Version: January 3, 2025

**Oregon Supplement to the
Manual on Uniform
Traffic Control Devices
for Streets and Highways
11th Edition**

This is a compilation of draft proposals for the Oregon Supplement to the MUTCD 11th Edition as of the version date above. This is not official Oregon Supplement content. This is provided for information only. ODOT might edit final proposed language to fit with the scope and style of the Oregon Supplement to the MUTCD.

Figure 8C-1(OR). Example of Placement of Warning Signs and Pavement Markings at Grade Crossings

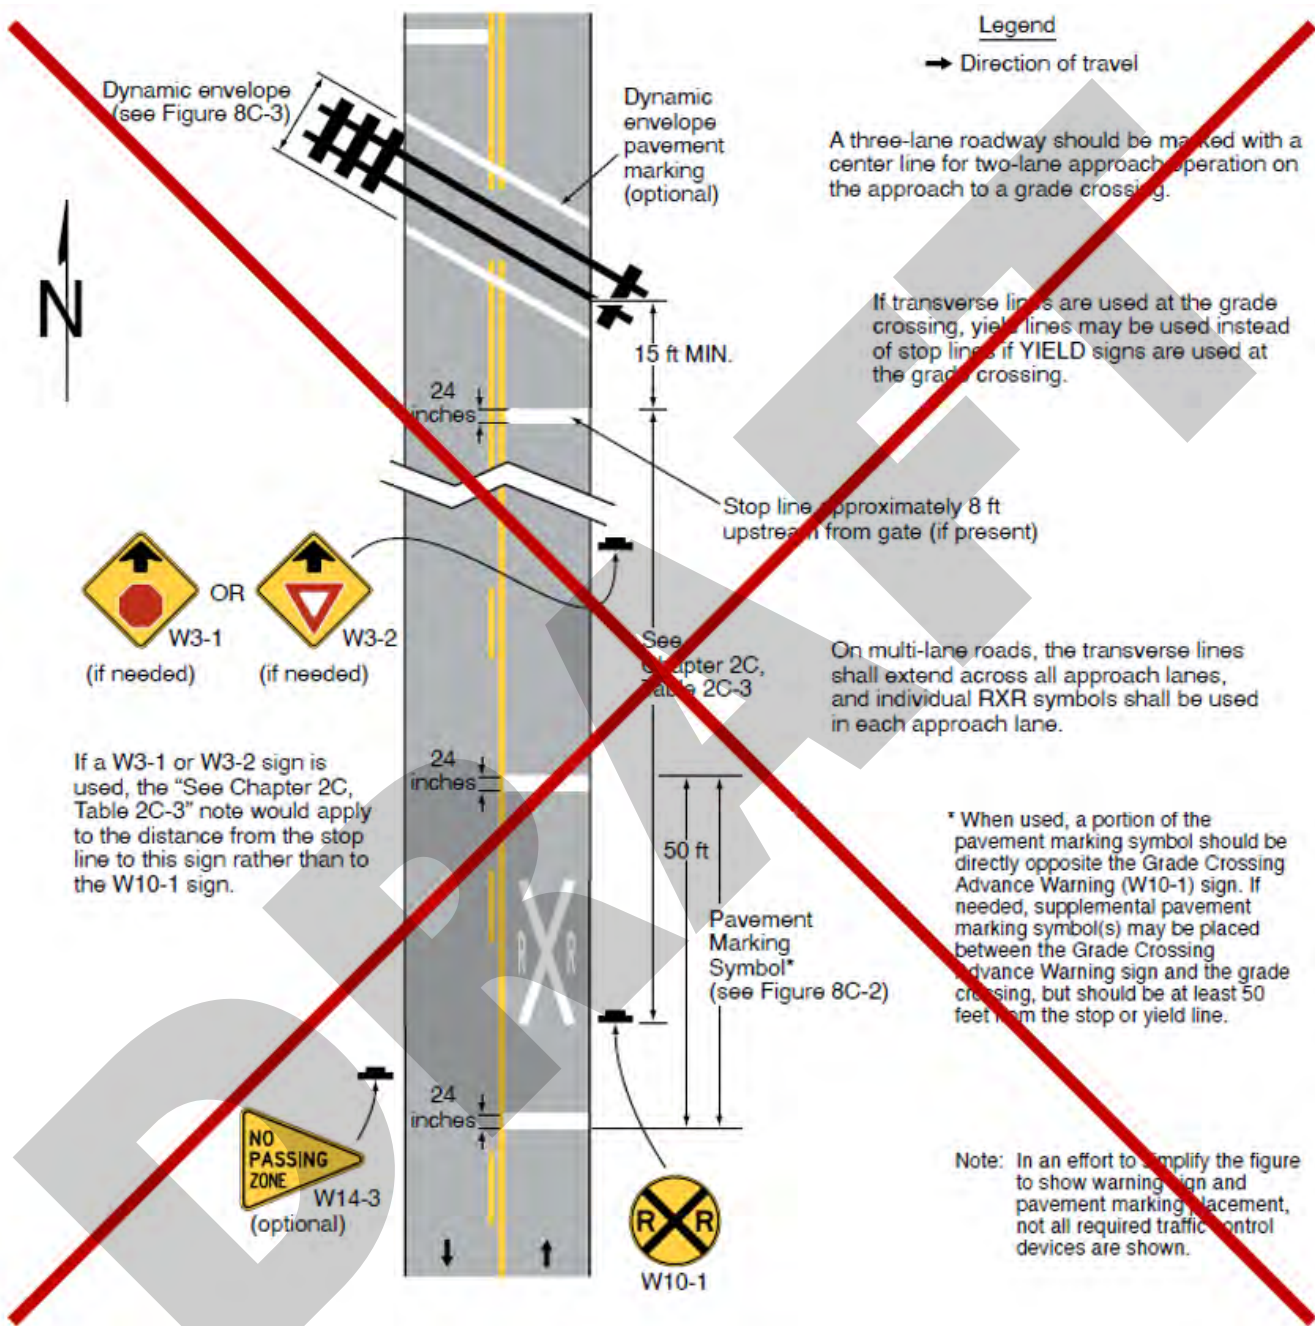
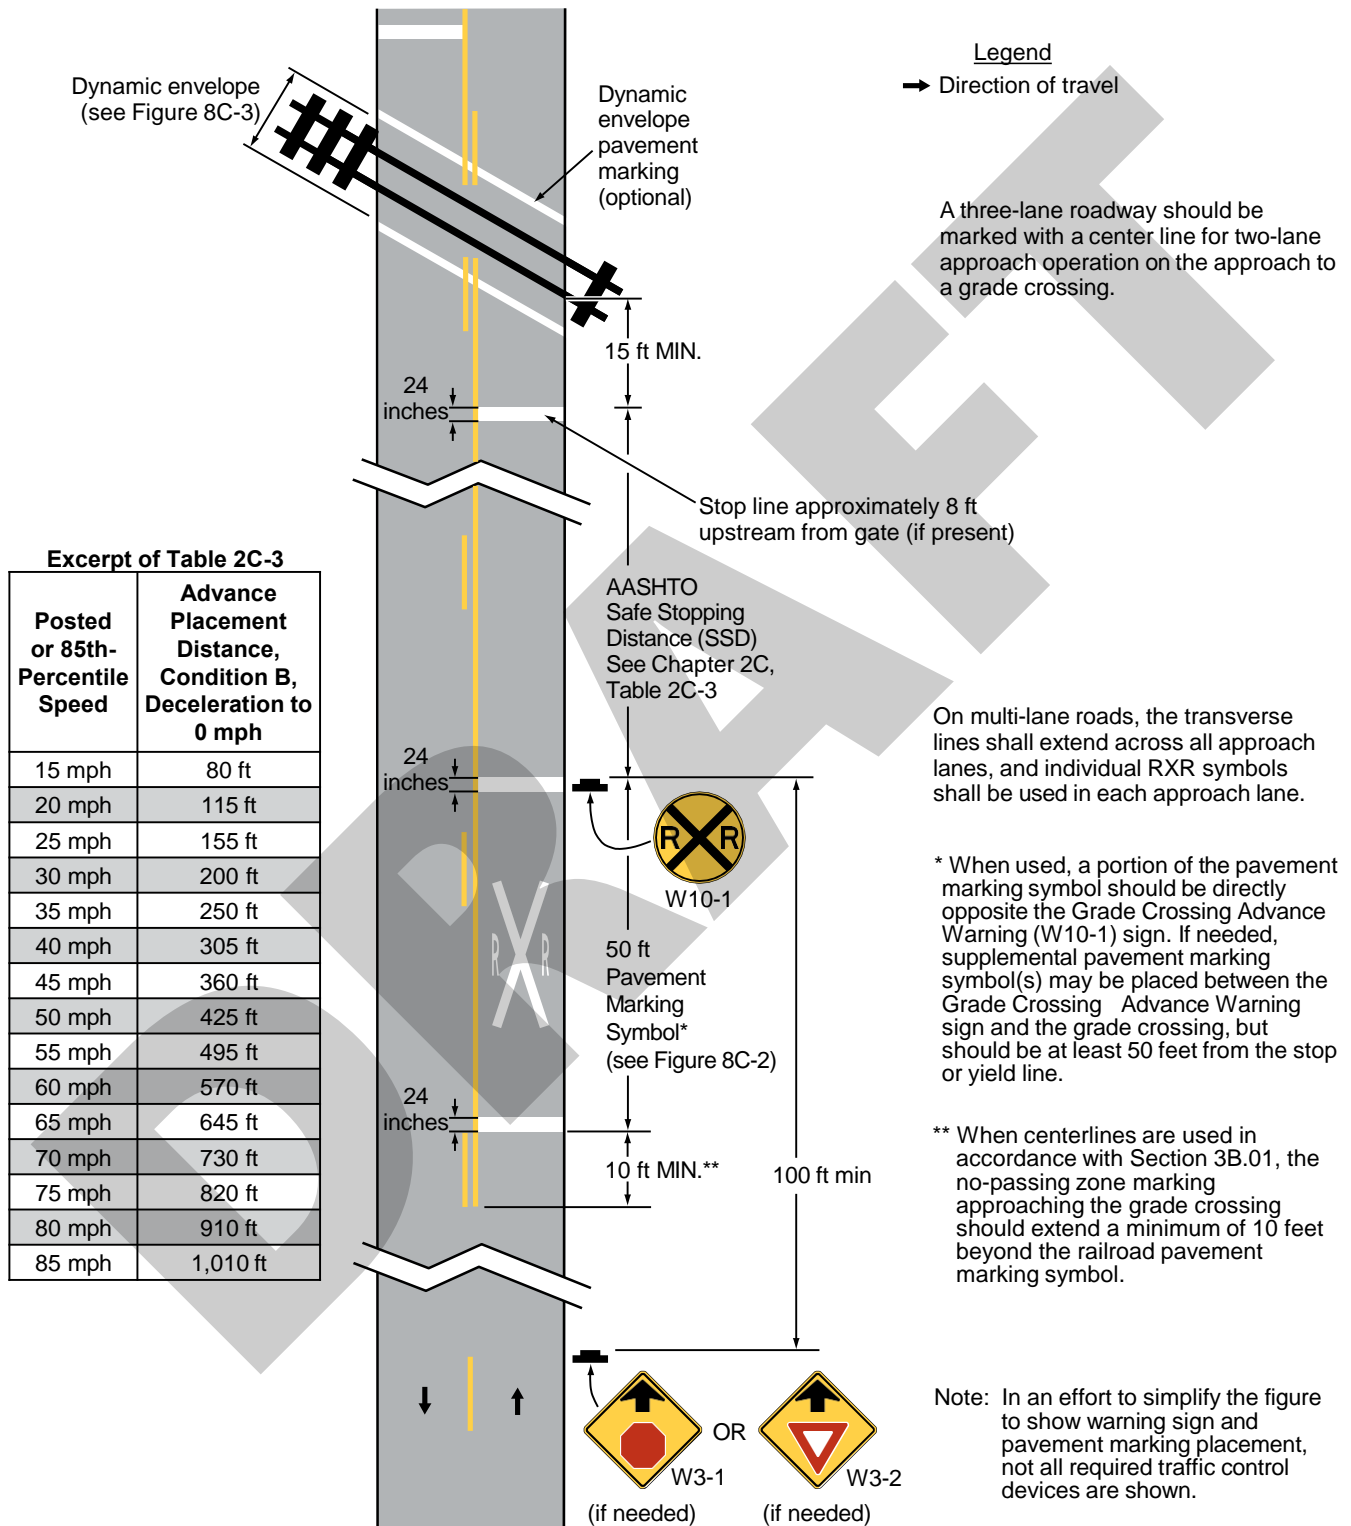
32 Note the MUTCD states in Section 3B.03 Paragraph 02 that no passing zone marking shall be used on
33 approaches to grade crossings (see Section 8C.02), but nowhere in the remainder of the MUTCD,
34 Section 8C.02 included, does the MUTCD specify where the no-pass striping should start for an
35 approach to a grade crossing. OAR Chapter 741 also does not include a specific OAR for the placement
36 of the centerline no-pass striping.

37 However, ODOT has a standard for the no-pass striping for an approach to a grade crossing in the
38 [ODOT Traffic Line Manual](#) Figure 510-B that requires the no-pass centerline striping extend 10 feet
39 beyond the RxR pavement marking placement, which coincides with the W10-1 sign placement. This
40 ODOT standard practice ensures that all advance warning pavement markings and signs associated
41 with the rail crossing are located together to provide a strong, cohesive message to the driver. As such,
42 this no-pass striping standard is now included on the proposed Figure 8C-1(OR) and should result in
43 increased uniformity and improved compliance and safety.

31 **Figure 3: Proposed Oregon Supplement layout, intersection stop line is the marked crosswalk**

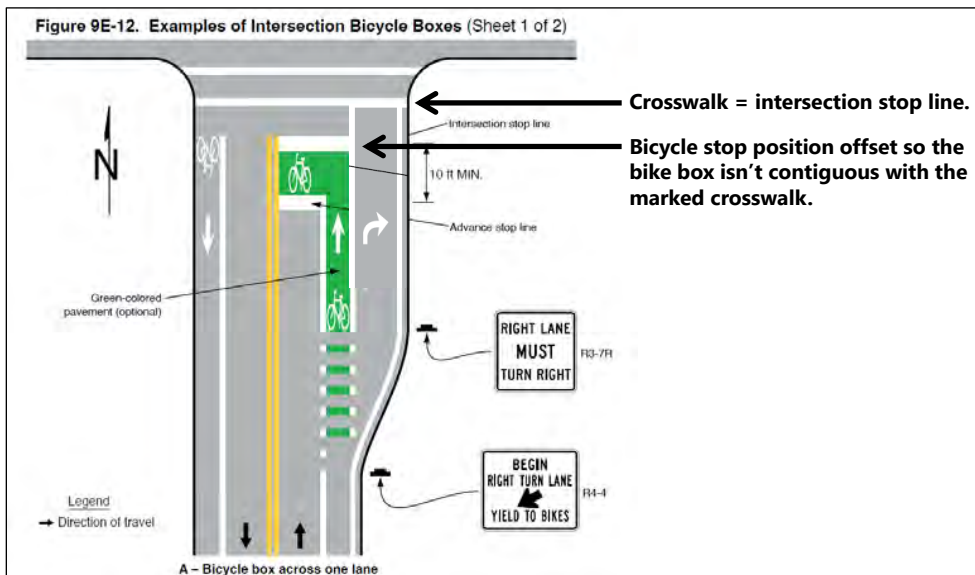
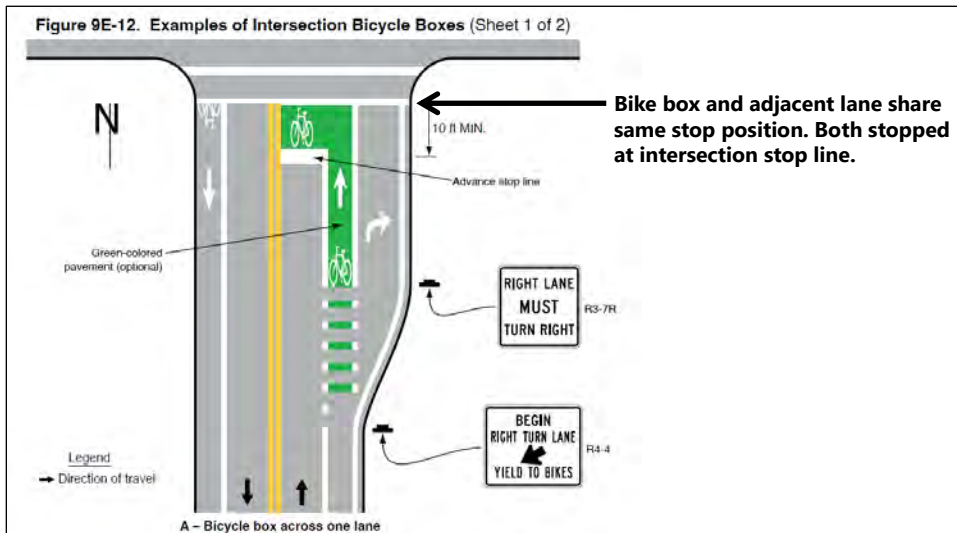
4 Section 9E.12 Paragraph 05 says a bicycle box should not be contiguous with a crosswalk, and a stop
5 line on the downstream end of the bicycle box should be used to mark the location where bicycles are
6 required to stop. However, Oregon has a long-standing practice (through Part 3 Oregon Supplement to
7 the MUTCD) of using the marked crosswalk as the intersection’s stop line (as in Proposal 11302).

24 If the marked crosswalk is the intersection’s stop line, then the Oregon Supplement should allow bike
25 boxes to be contiguous with the marked crosswalk so the bike box and adjacent lane stop positions can
26 share the same stop position – the intersection stop line – shown in Figure 3. This is how road
27 authorities have installed bicycle boxes in Oregon to date. Figure 4 shows an example. This is also
28 supported by the support statement in 9E.02 Paragraph 17: “Staggering stop lines (see Section 3B.19) so
29 that general-purpose lanes stop further in advance from the intersection than the bicycle lane can
30 improve the visibility of bicyclists for drivers of turning vehicles (see Drawing D in Figure 9E-7).”
